**Comments on the Development Code Variances Submittal  
For the CPAH Plambeck Gardens Planning Documents  
Made Available by the City of Tualatin Planning Department (October 2021)**

**PLAMBECK GARDENS**  
 23500 & 23550 SW BOONES FERRY ROAD  
 TUALATIN, OREGON 97062  
 LAND USE VARIANCE APPLICATION  
 09.02.2021

**RE: City of Tualatin Planning Commission Hearing 11-18-2021**

**Figure 1. LEA Text Overlay on CPAH Site Plan Background. Showing Infiltrating Stormwater Planters in Vicinity of 4-Story Buildings Variance Would Allow.**

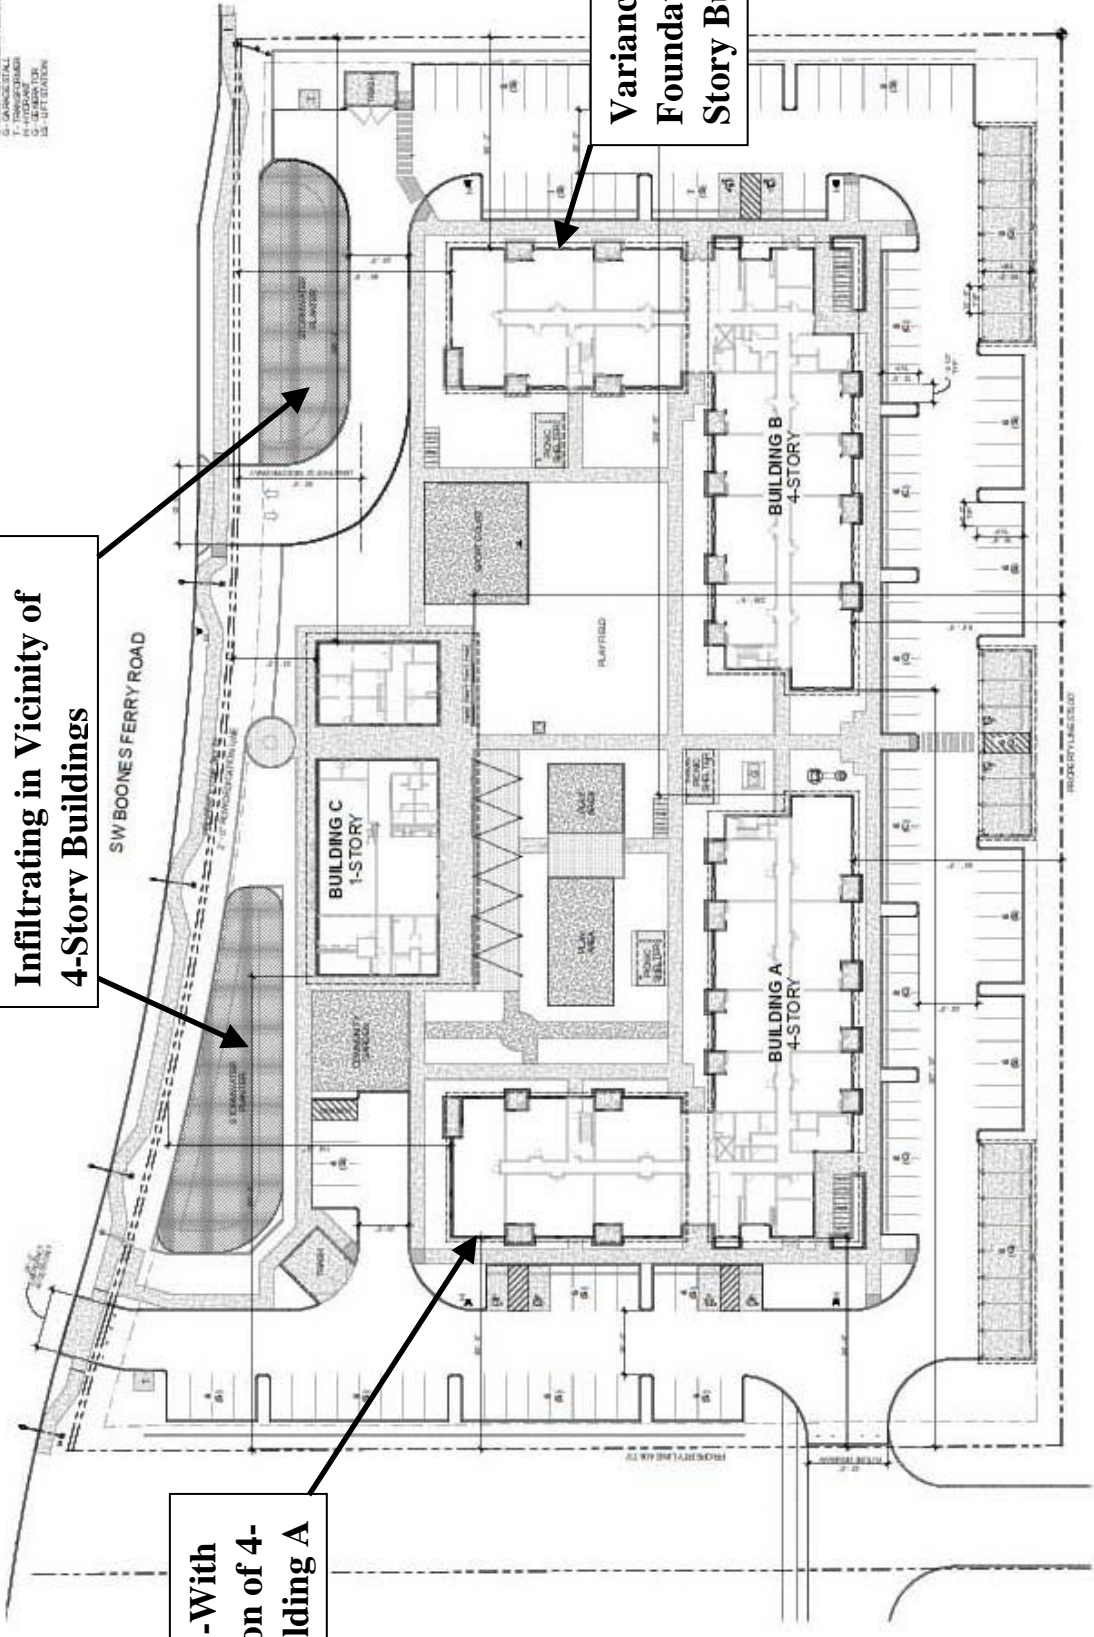
Figures for these comments are contained at the end of this report. The CPAH Site Plan is excerpted in these comments as the background in Figure 1. The plan was included with the CPAH Variances Submittal. It proposes to eliminate stormwater runoff using infiltration in the “Stormwater Planters”, pervious parking areas, and other parts of the development site.

The effect on “landslide susceptibility” at the site is unevaluated and no stormwater analysis has been provided by CPAH. During wet weather conditions, the potential for saturated soils and high groundwater conditions is significant in the planned vicinity of the two foundations of the 4-story buildings

**Stormwater Planters Infiltrating in Vicinity of 4-Story Buildings**

**Variance - With Foundation of 4-Story Building A**

**Variance - With Foundation of 4-Story Building B**

**Figure 2. Southwest (SW) Section depicting the 4-Story Variance with a foundation segment of CPAH Building A - Grading Plan. Showing proximity of the stormwater infiltration facility. Text and graphic overlay by LEA.**

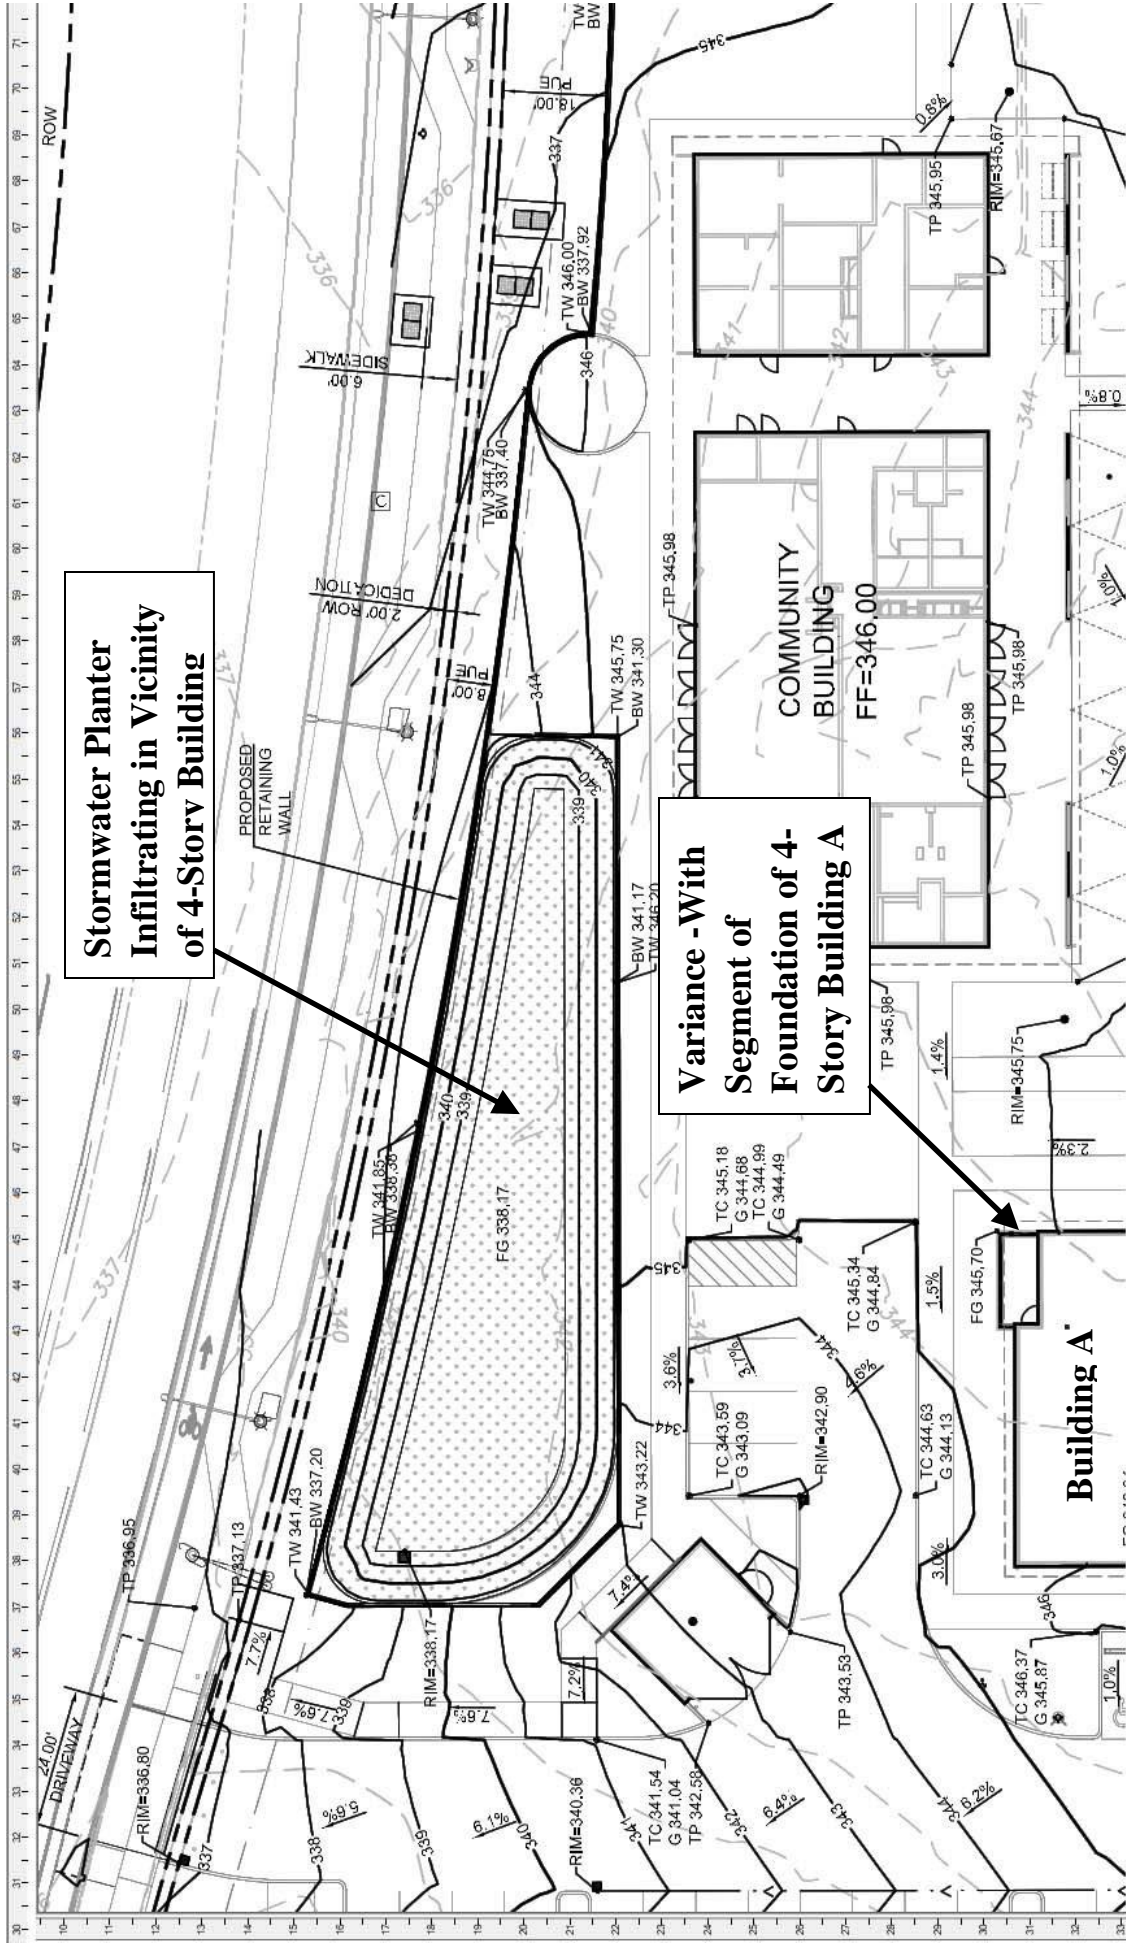
The claimed steep slopes and areas of “unsuitable soils” are shown in the sections depicted in the CPAH Grading Plan. See sections Figure 2 – Southwest, and Figure 3 – Northeast and Figure 4 - Northwest. These sections contradict the conditions categorized by CPAH as “undevelopable”. This includes the taller 4-story buildings requiring the height and reduced parking

**Figure 3. Northeast (NE) Section of the CPAH Variance for Two Building Configuration - Grading Plan. The foundation and associated grading of Building B is built into the “hill”. This is inconsistently described as “undevelopable” in the variance submittal. Text and graphic overlay by LEA.**

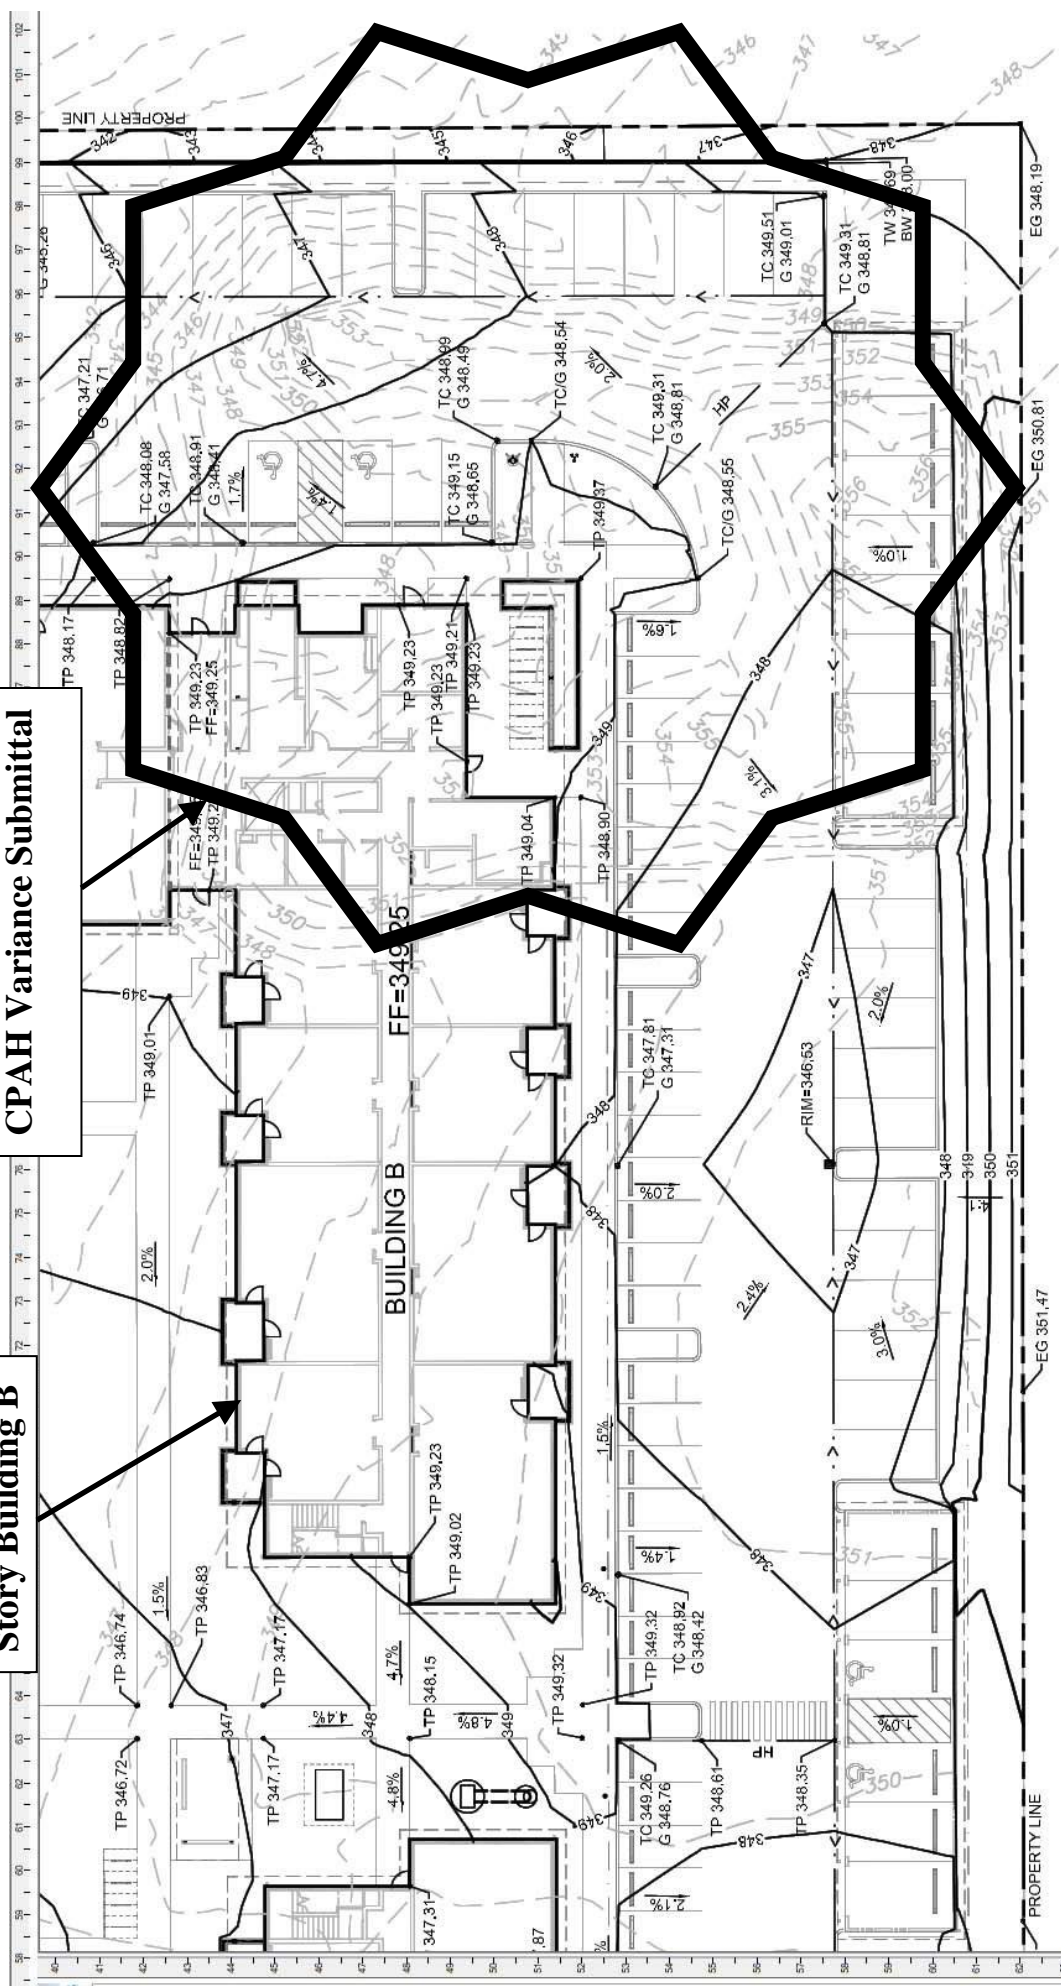
**“hill” described as “undevelopable” in the CPAH Variance Submittal**

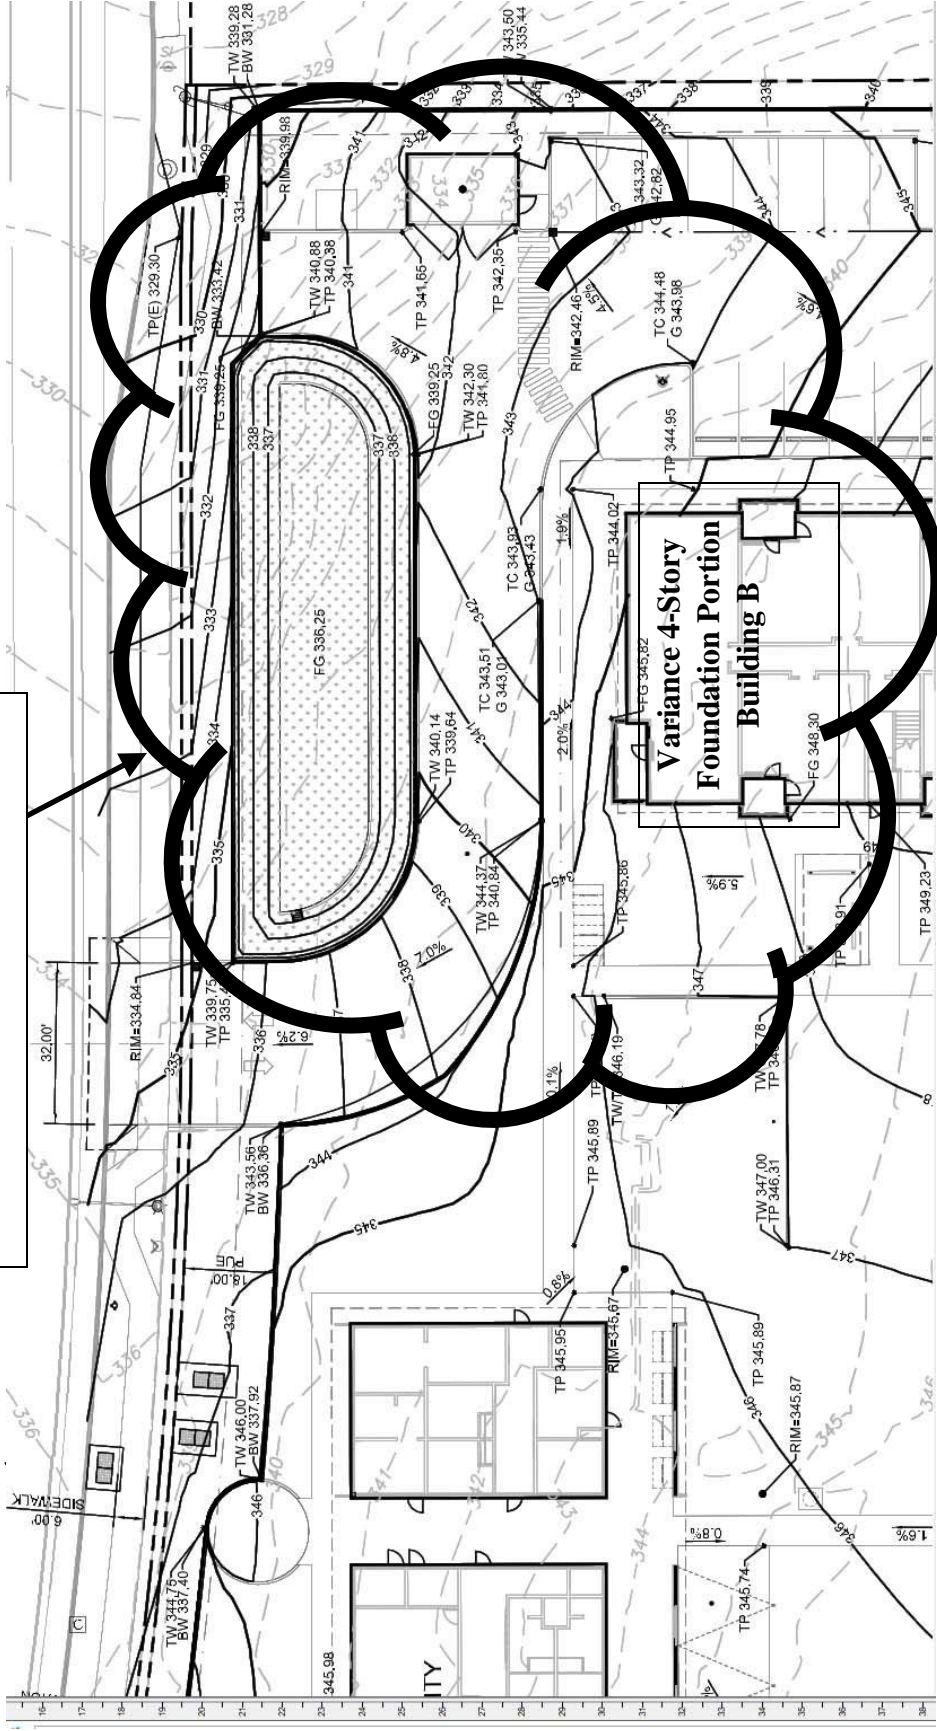
Described as “particularly steep” & “undevelopable” in the CPAH Variance Submittal
